Our Ref: 217143\_LET\_007A.docx

**MODIFICATION OF SSD8095, WALGETT SOLAR FARM – MINOR AMENDMENT TO APPROVED PLANS WITH RESPECT TO SITE ACCESS**

Access Road Realignment  
Walgett Solar Farm  
Walgett Solar Pty Ltd  
Approved / Proposed Access Plan

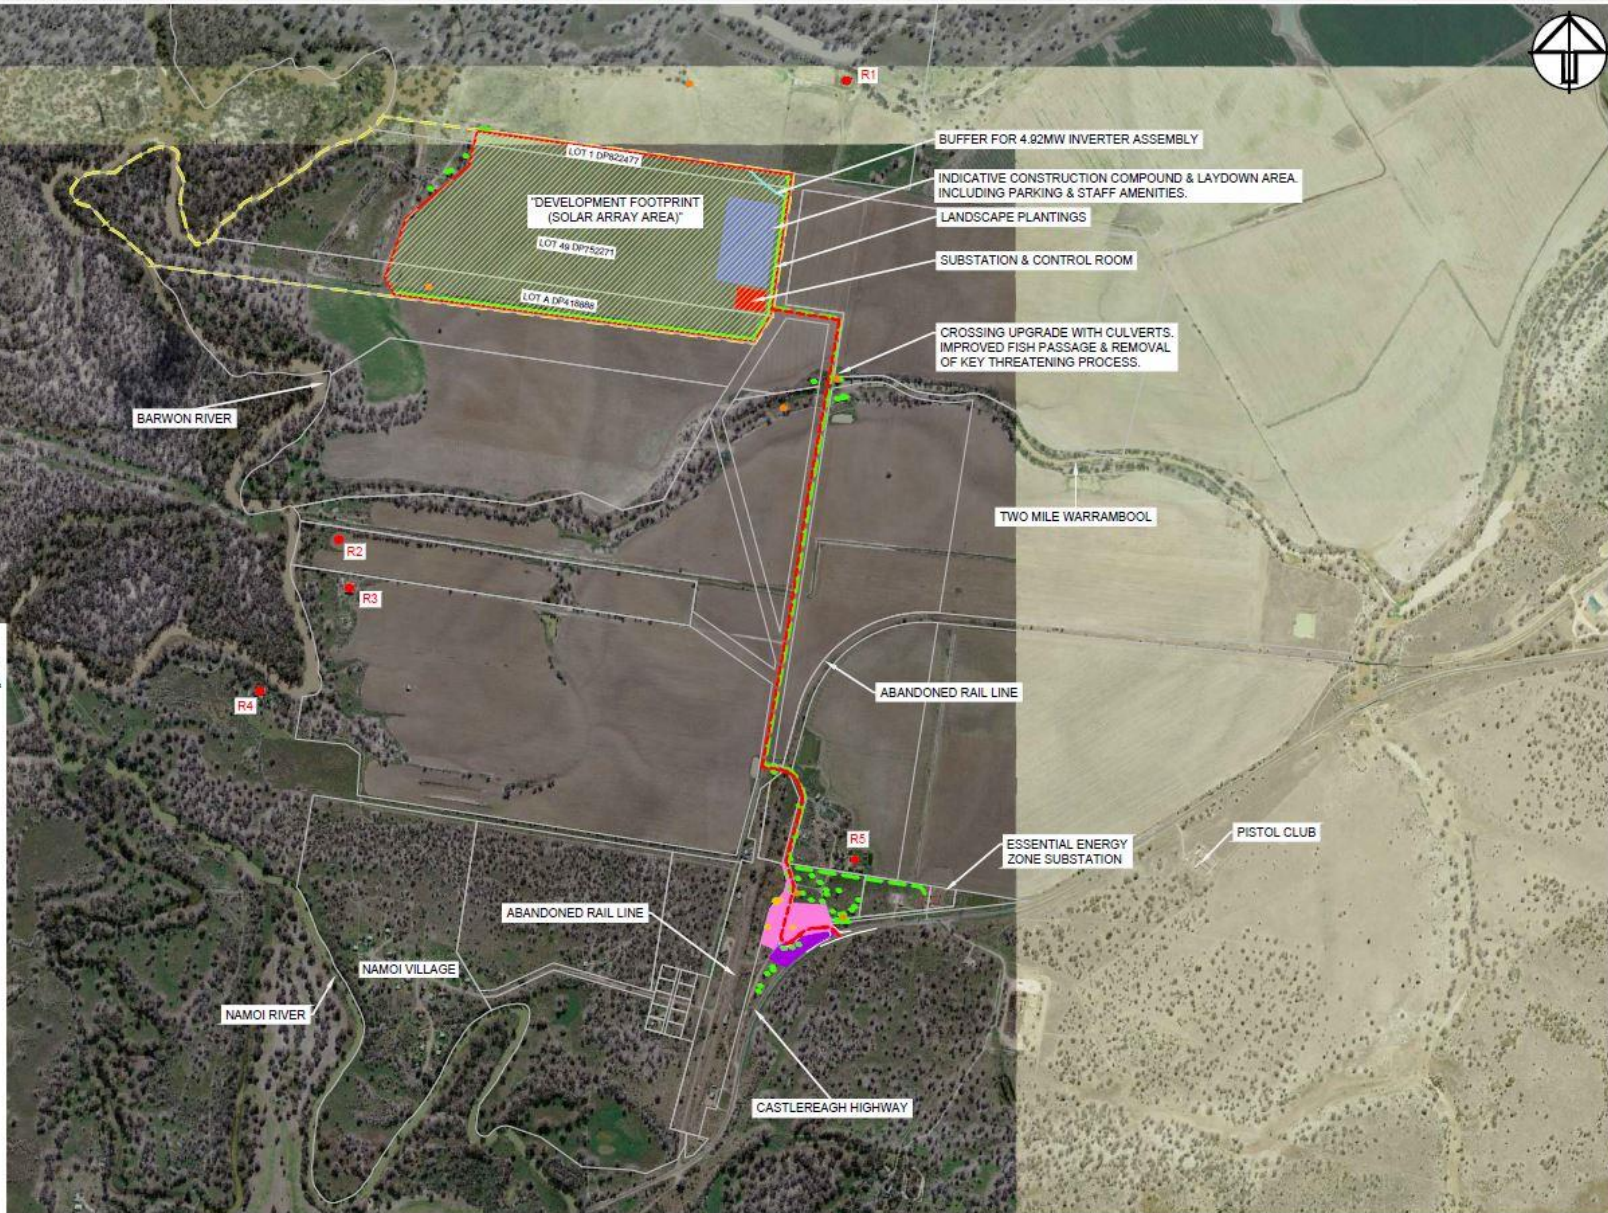
**Attachment 1** provides three drawings, being the approved layout as per SSD 8095, which demonstrates the current approved arrangement with respect to access, **Geolyse Drawing 2: Access Road Realignment**, which demonstrates the proposed arrangement as sought via this modification and **BSR Site Access Treatment Drawing 1577-0700-01**.

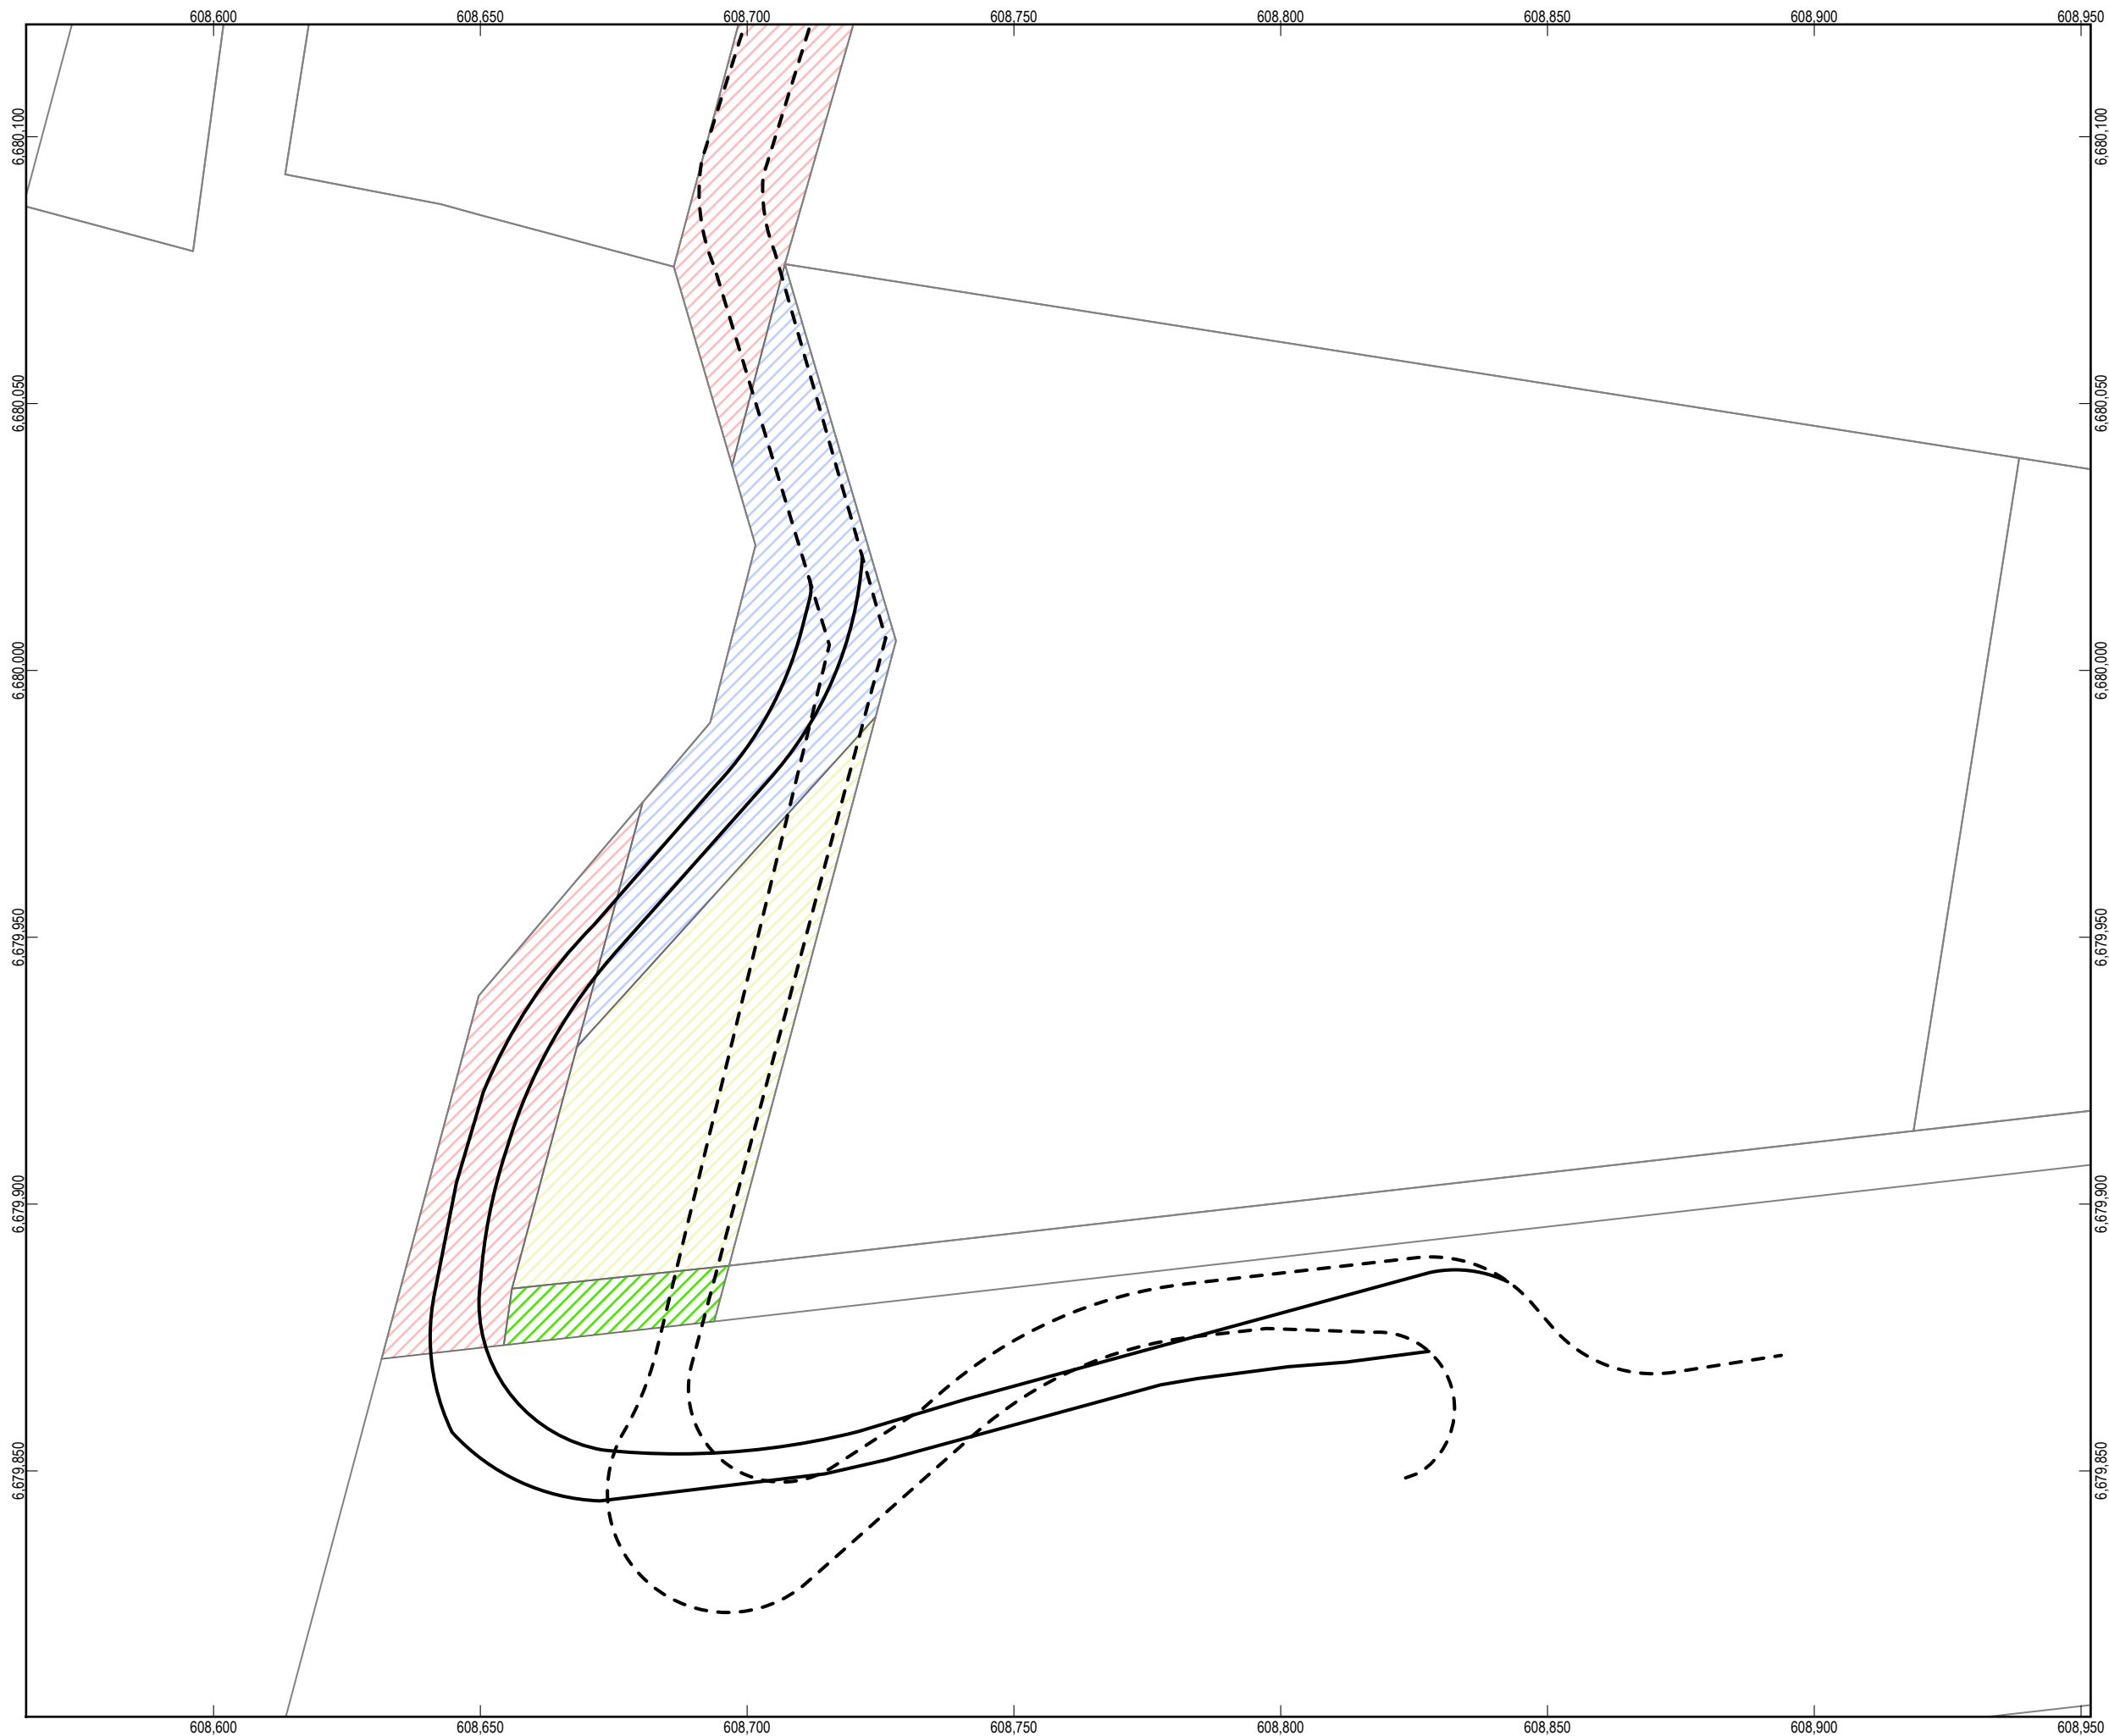
The proposed modification relates to amendments to the site access route to avoid crossing Crown land.

Figure 1

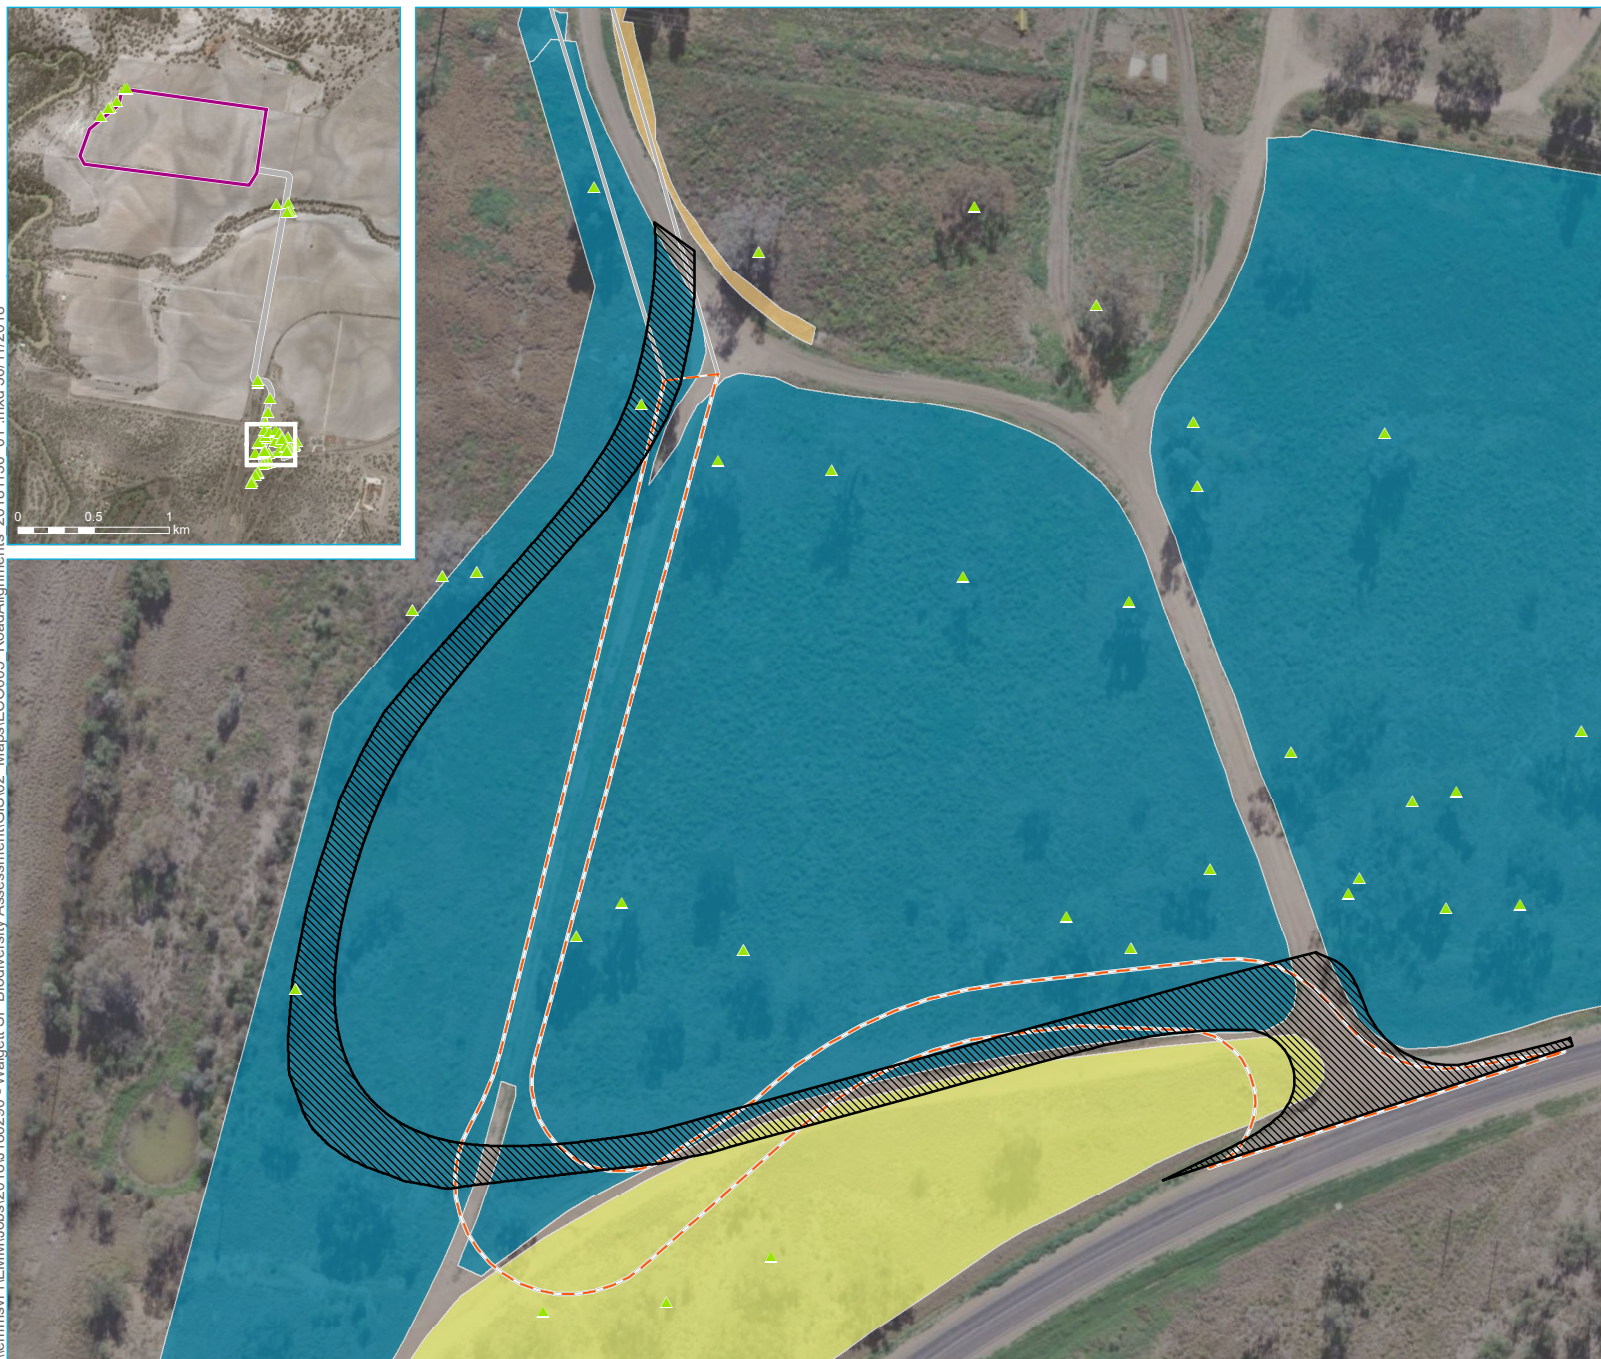
It has now been identified that a small portion of the proposed access track for the Walgett Solar Farm is located on Crown land. As a result, the access track needs to be moved approximately 40 m west of the original alignment approved as part of the original development plan (Figure 1). Geolyse, on behalf of Walgett Solar, is preparing a modification to the original approval for this revised road alignment. This letter report sets out the revised impact biodiversity impact assessment.

Impacts arising from the original and revised road alignments are summarised in Table 1 and shown in Figure 1.

The revised road alignment will result in an overall reduction in impacts arising from the Walgett Solar Farm from 0.38 ha (0.63 ha inclusive of grid connection) to 0.29 ha (0.54 ha inclusive of grid connection). There is a concurrent reduction in credits required to offset impacts from 2 to 1 credit. Walgett Solar will make payment into the Biodiversity Conservation Fund (BCF) to retire this credit requirement.

Figure 4.1

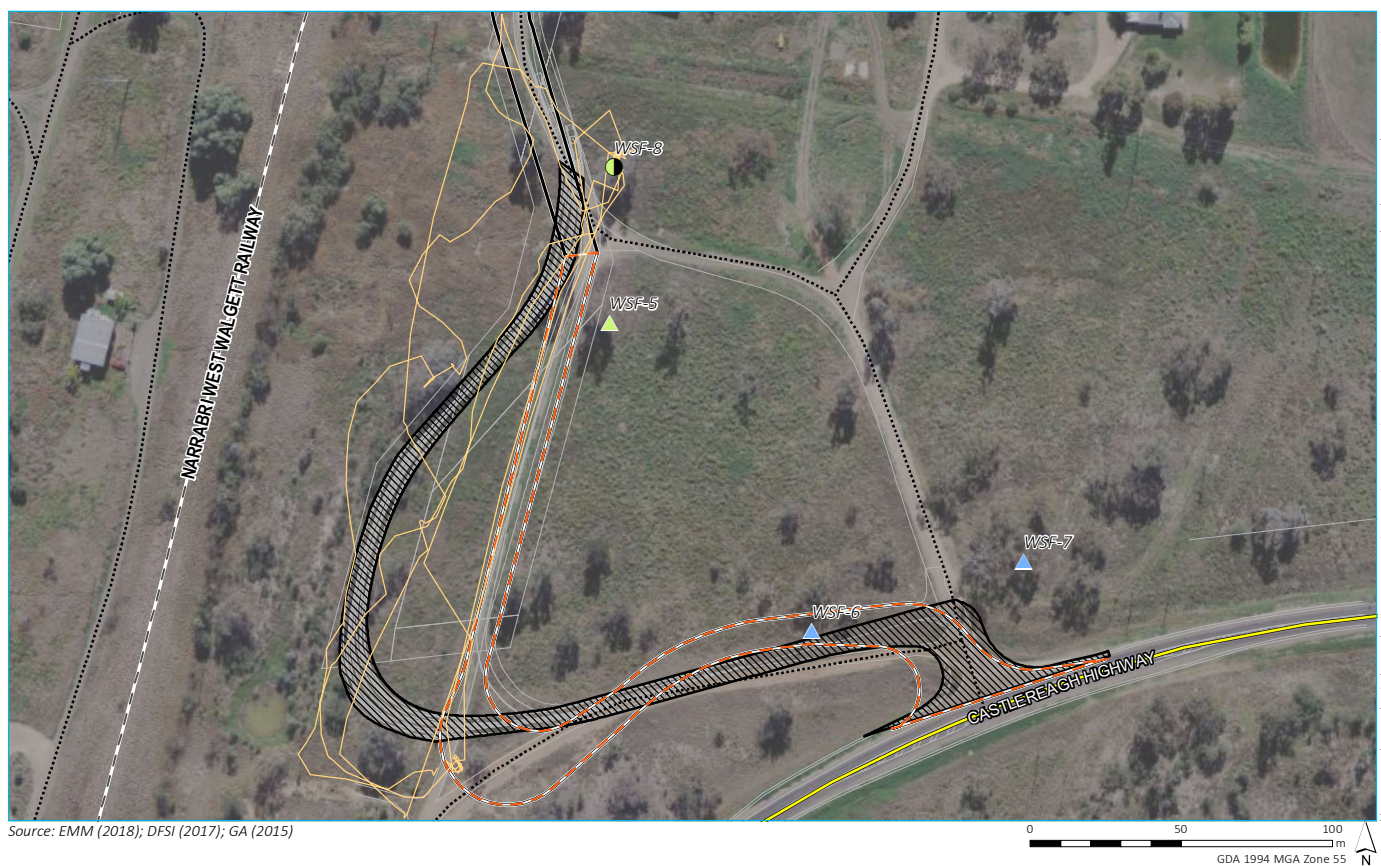
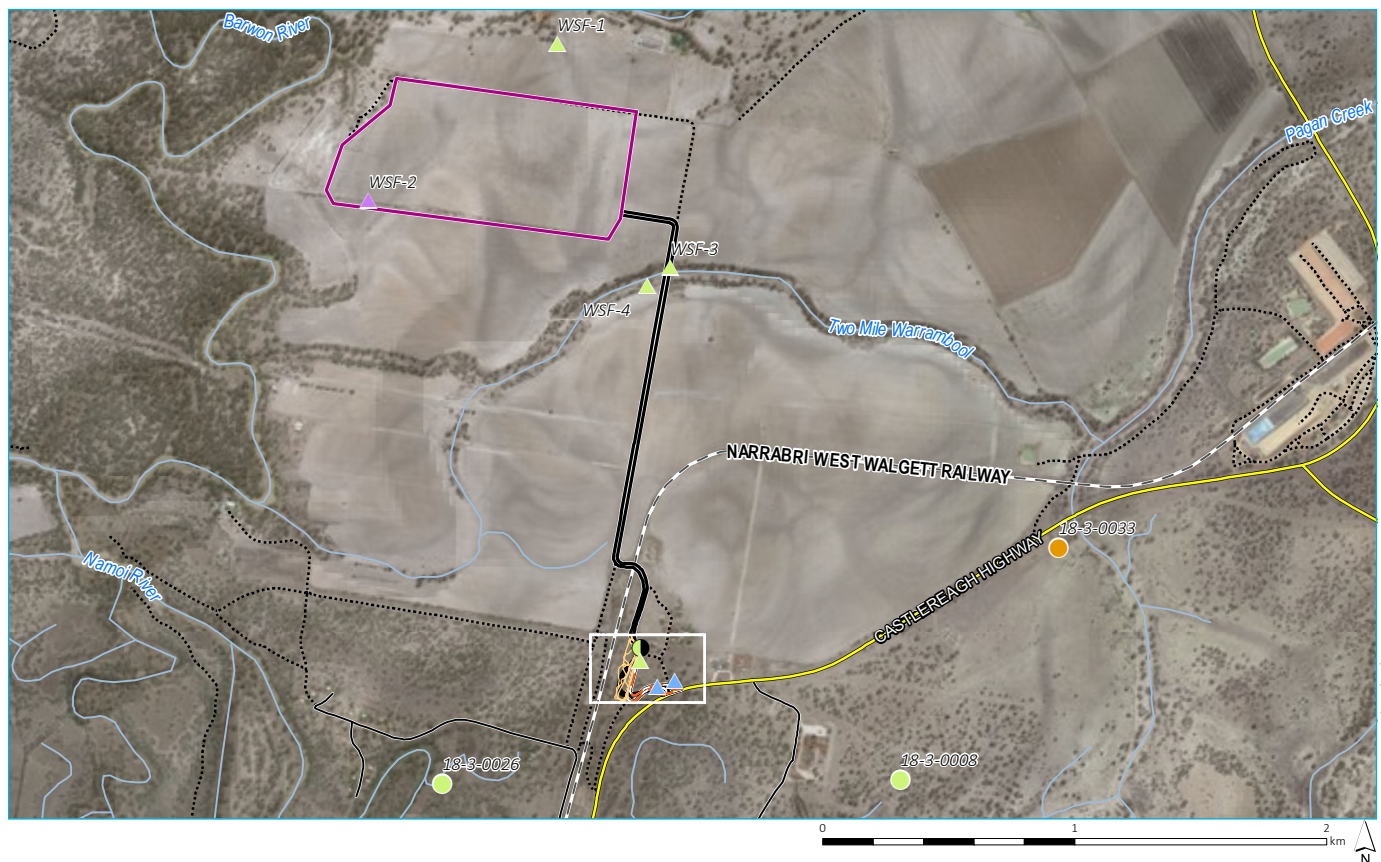
One new scarred tree, WSF-8, was identified as a result of the survey (refer to Table 4.2 and Figure 4.1). The scar is regular in shape and displays a significant amount of regrowth. WSF-8 is assessed as a possible scar of Aboriginal origin, however two metal fastenings were observed in the north and north-western face of the trunk which indicate the tree may also have been utilised for historical purposes.

Scarred tree WSF-8 is located outside of the proposed impact footprint and no other Aboriginal objects or areas of potential archaeological deposit were identified within the proposed access track realignment area. As such it is assessed that the proposal has low potential to impact Aboriginal sites.

- The proposed access track realignment may proceed with no further archaeological assessment.
- The proponent must exercise caution when completing works in the vicinity of scarred tree WSF-8 to avoid inadvertent impacts.
- All workers (including contractors) should be made aware that it is an offence under the *National Parks and Wildlife Act 1974* to destroy, deface or otherwise disturb an Aboriginal object without first obtaining the consent of the Director General of the NSW NPWS.
